Pontoon Mount Washer

Models Affected

Models Covered	Year
MBK300132 MBK300052	Pontoon mount manufactured from 07/06/02 through 01/01/05

Pontoon mount washer

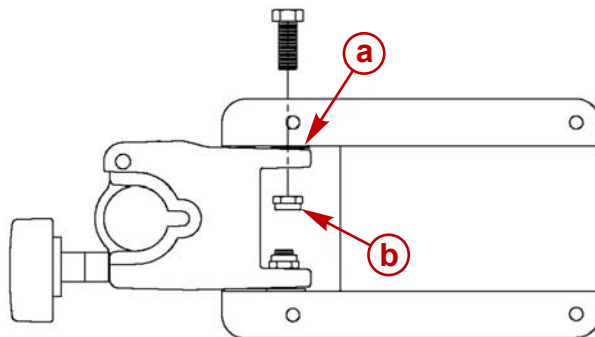
Inner bracket does not center properly causing dimensional issues with the mounting plate.

Remove four (4) pieces of MXT01101 stainless steel washers. Add four (4) pieces of MRK17102 nylon washers per diagram. Tighten the bolts to specifications.

Description	Nm	lb. in.	lb. ft.
Bolts	33.9		25
